E4416A-16

S E R V I C E N O T E

E4416A EPM-P Single Channel Power Meter

Overload Failure in W-CDMA & HSDPA Signal Measurement when RF Input Exceeds -1dBm

Figure 2: Defective Component Checking (1820-6472) on Measurement Board (E4416-60004)

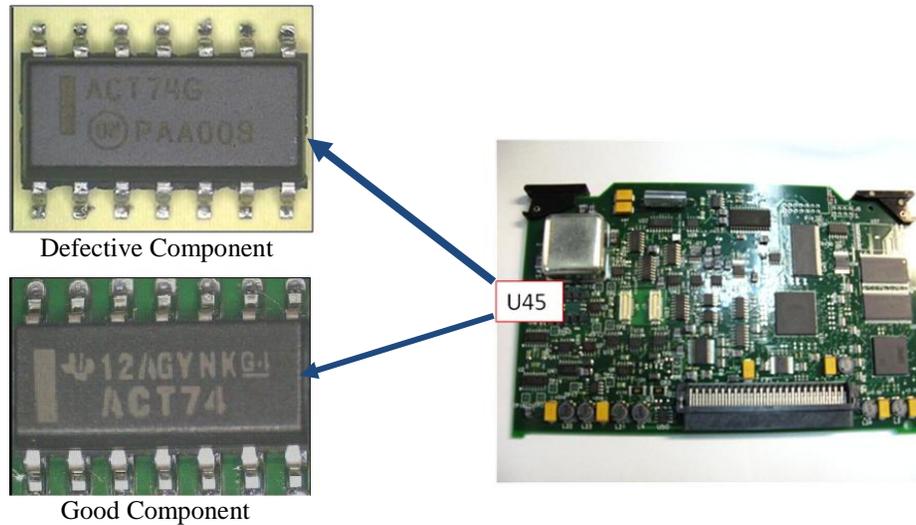
2. This problem is caused by a flip-flop amplifier component from a specific supplier that carries the part number: 1820-6473 this supplier's component is used on the E4416-60004. Only boards build with this supplier's 1820-6472 component will exhibit this issue.
3. The following test steps shows how the 'overload' error can be reproduced:
 - a) Power On the E4416A
 - b) Connect the E9320 Series peak & average power sensor to the E4416A
 - c) Perform zeroing & calibration for the power sensor
 - d) Preset the E4416A to W-CDMA mode
 - e) Connect the power sensor to a signal generator
 - f) Set the signal generator to output W-CDMA or HSDPA signal with starting RF power level at -10dBm
 - g) Turn ON "RF Output" of the signal generator
 - h) Increase the RF input power with 1dBm step
 - i) The overload failure will be noticed once the RF power level above -1dBm

1. Customer can contact Agilent’s Customer Contact Center (CCC) to return the unit to Agilent’s Service Center for rework if this symptom is observed.
2. Agilent’s Service Center will replace the affected measurement board (E4416-60004) with a new measurement board that is build with a good 1820-6472 (component locator U45) to resolve this symptom.
3. Prior to board replacement, Agilent’s Service Center will need to visually reconfirm measurement board from the customer’s unit is indeed build with the defective part. The defective part can be visually differentiated form the markings on the component, as shown below:

4. After replacing the measurement board that uses the good 1820-6472 component, follow the procedured below to perform verification on the power meter:
 - a) Power ON the E4416A
 - b) Perform “Self Test” from the front panel of the E4416A to ensure all tests passed
 - c) Perform the verification test with the STE 9000 calibration software to ensure the accuracy of the E4416A. The following are the required tests in STE 9000 and it’s test duration:
